Well Name: LITTLE STINKER	Well Location: T30N / R12W / SEC 11 / NESE / 36.824971 / -108.060876	County or Parish/State: SAN JUAN / NM
Well Number: 3	Type of Well: CONVENTIONAL GAS WELL	Allottee or Tribe Name:
Lease Number: NMSF081239	Unit or CA Name: BASIN DAKOTA, BLANCO MESAVERDE, FRCL - E/2	Unit or CA Number: NMNM102938, NMNM104857, NMNM104870
US Well Number: 3004532305	Operator: HILCORP ENERGY COMPANY

Notice of Intent

Type of Action: Plug and Abandonment

CONDITIONS OF APPROVAL

LITTLE STINKER 3 - PROPOSED WELLBORE SCHEMATIC

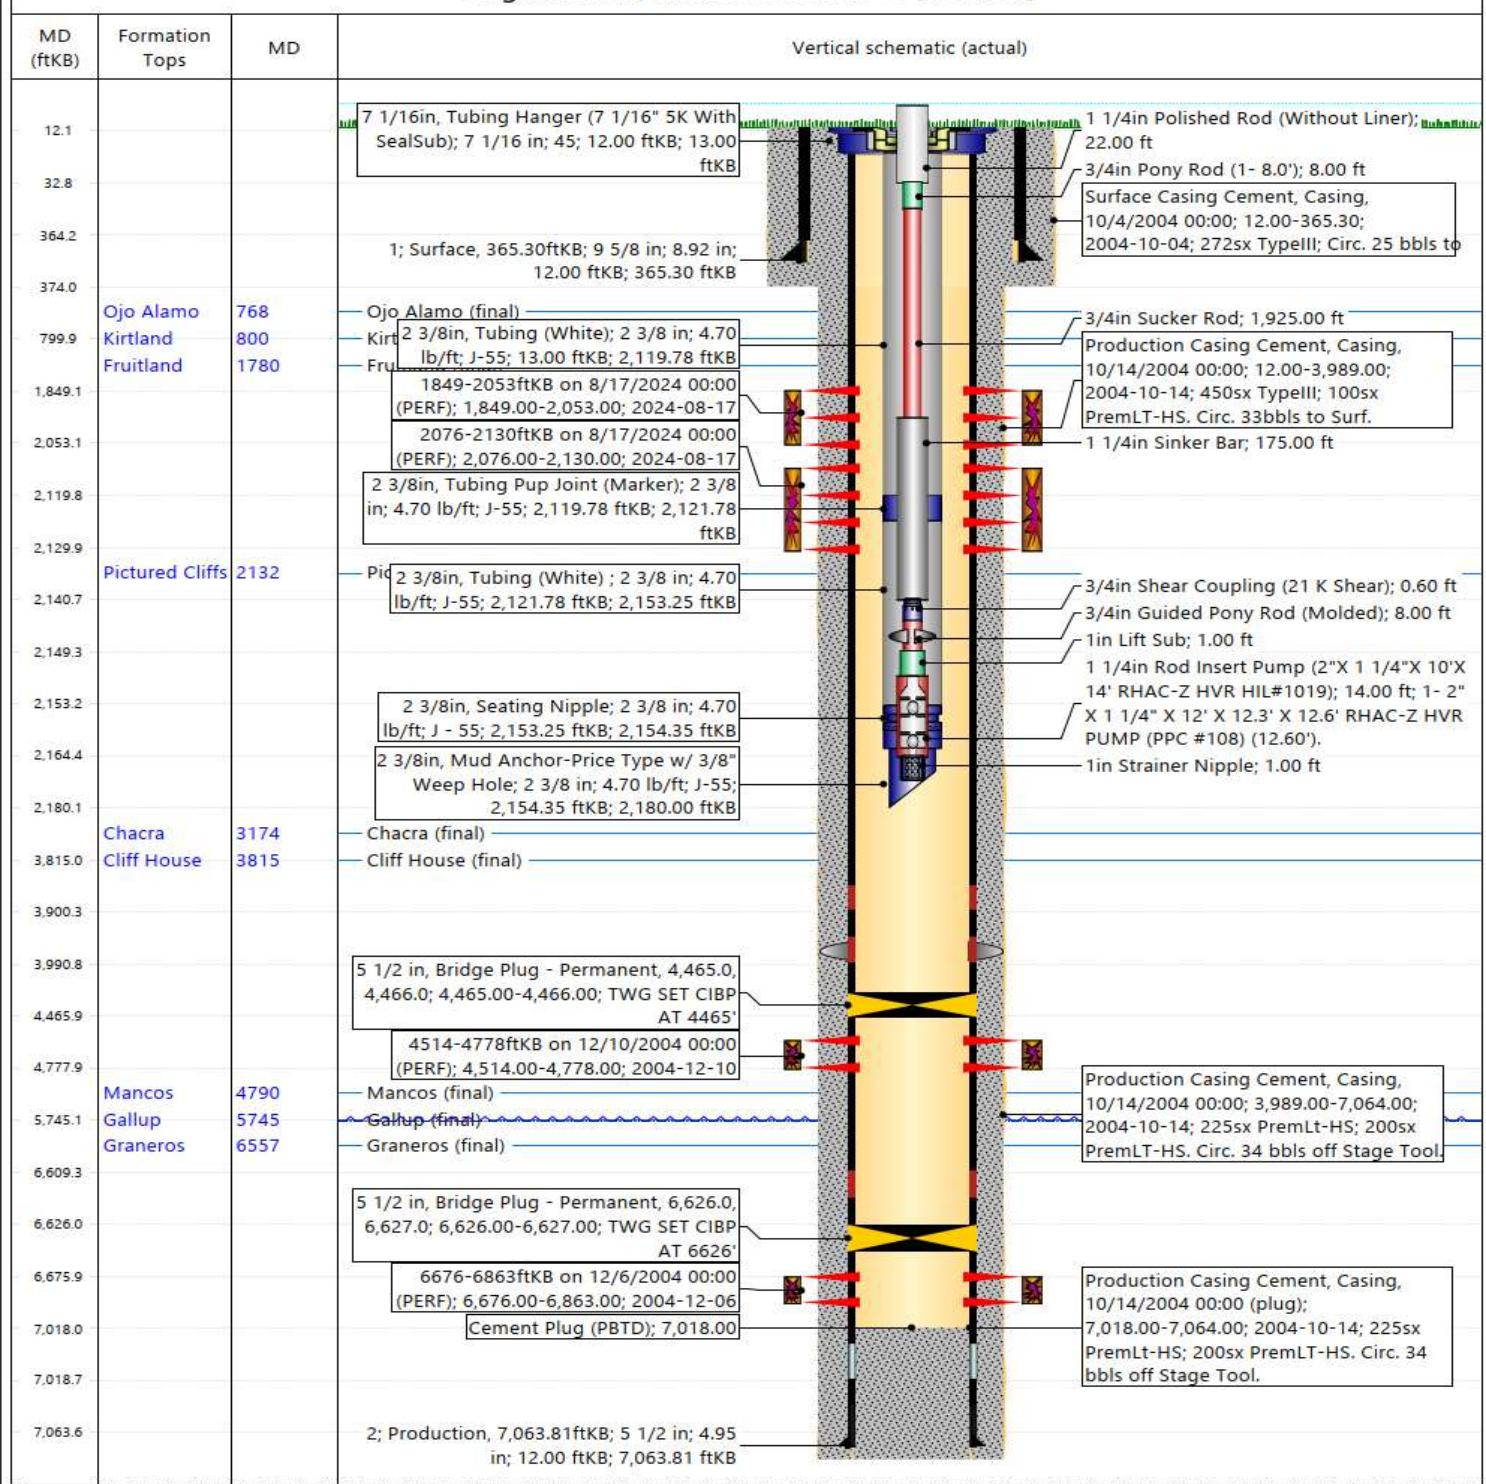
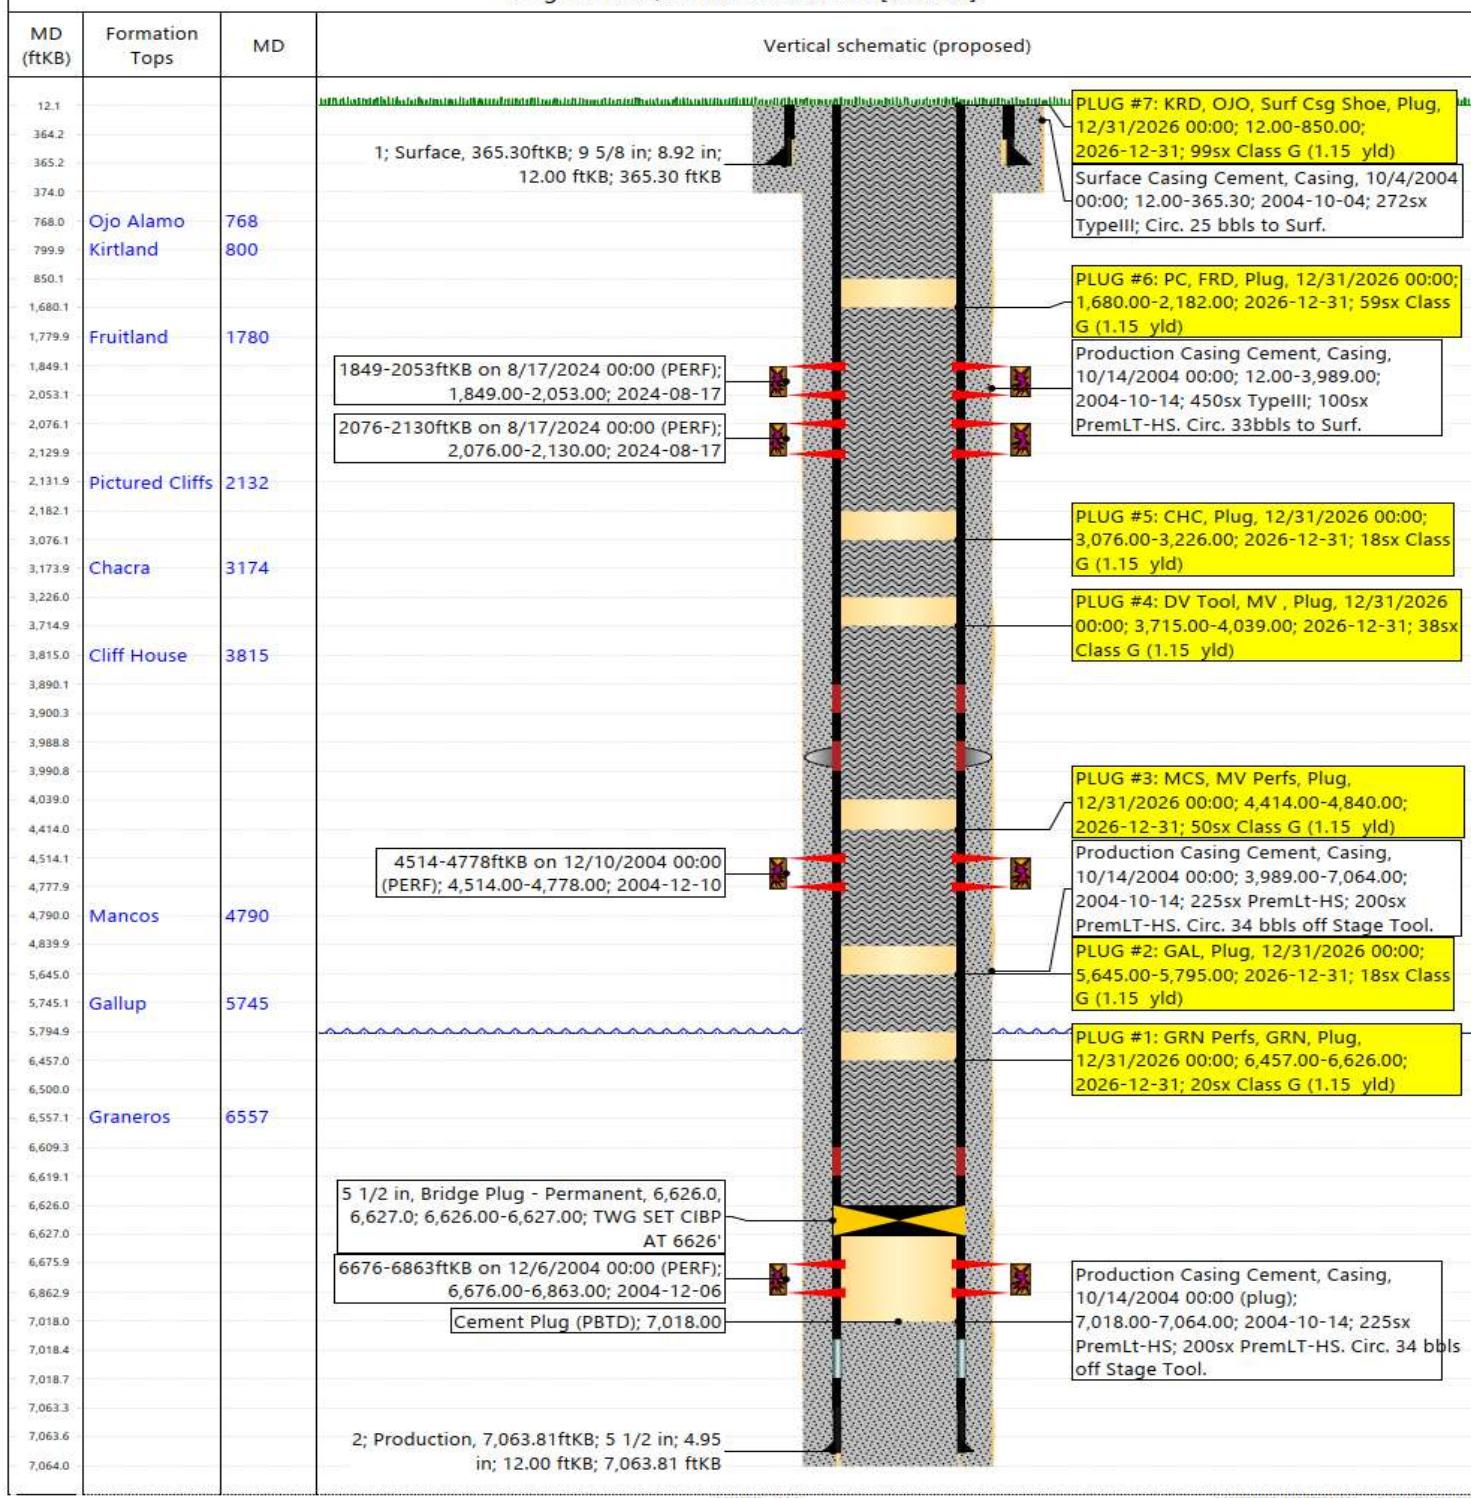
1. Plugging operations authorized are subject to the attached "General Requirements for Permanent Abandonment of Wells on Federal and Indian Lease."
2. The following modifications to your plugging program are to be made:
 - a. There is a CIBP located at 4465' in the Original Schematic. It is missing in the Proposed Schematic and its removal is not mentioned in the Procedure. The CIBP disposition should be determined before this P&A can be approved.
 - b. Modify Plug 4. Make the TOC 3620' to cover the BLM geologist's pick for the Cliff House at 3720'.
 - c. Modify Plug 5. Make the TOC 2885' to cover the BLM geologist's pick for the Chacra at 2985'.
3. **Notification:** Farmington Office is to be notified at least 24 hours before the plugging operations commence at (505) 564 7750.

- Vertical wellbore, all formation depths are TVD from KB at the wellhead.
- There is a CIBP located at 4465' in the Original Schematic. It is missing in the Proposed Schematic and its removal is not mentioned in the Procedure. The CIBP disposition should be determined before this P&A can be approved.
- Modify Plug 4. Make the TOC 3620' to cover the BLM geologist's pick for the Cliff House.
- Modify Plug 5. Make the TOC 2885' to cover the BLM geologist's pick for the Chacra
